Access Compliance Report Public Rights-of-Way (Curb Ramps)

Main Street: N/A Cross Street: HOLT_AVE Location: W

ADA ID: RPRK211011134029 Ramp Type: Type 6 - Directional 1 Initial Pass/Fail: Fail Overall Compliance: No Severity Score: 2

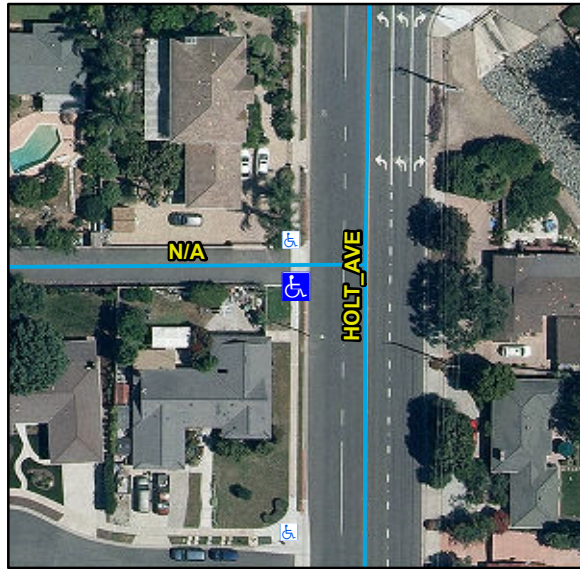
R204.3, R304.5.3, STD 1115

Compliance	Description	Data	Compliance	Description	Data
N/A	Ramp Length (in)	72	N/A	Flare Type LT	
Yes	Ramp Width (in)	48			N/A
Yes	Ramp Run Slope (%)	6	N/A	Flare Slope LT (%)	N/A
No	Ramp Cross Slope (%)	3.1	N/A	Flare Traversable LT	N/A
N/A	Grade Break	N/A	N/A	Flare Type RT	
N/A	Grade Break Slope (%)	N/A			N/A
N/A	Grade Break Cross Slope (%)	N/A	N/A	Flare Slope RT (%)	N/A
	Addl Para Ramp Left?	No	N/A	Flare Traversable RT	N/A
	Addl Para Ramp Right?	No	N/A	DWS Provided	N/A
N/A	Landing Present	N/A	N/A	DWS Contrast	N/A
N/A	Landing Length (in)	N/A	N/A	DWS Length (in)	N/A
N/A	Landing Width (in)	N/A	N/A	DWS Full Width	N/A
N/A	Landing Run Slope (%)	N/A		DWS Offset Type	N/A
N/A	Landing Cross Slope (%)	N/A	N/A	DWS Left Offset (in)	N/A
N/A	Landing Movement Obstructed?	N/A	N/A	DWS Right Offset (in)	N/A
	Landing Movement Type	N/A			
N/A	Landing Shared	N/A			
N/A	Marked Crosswalk 1	No	N/A	Clear Space	N/A
	Crossing 1 Direction	N	N/A	Clear Space To Crosswalk (in)	N/A

Remove & Replace Entire Ramp.
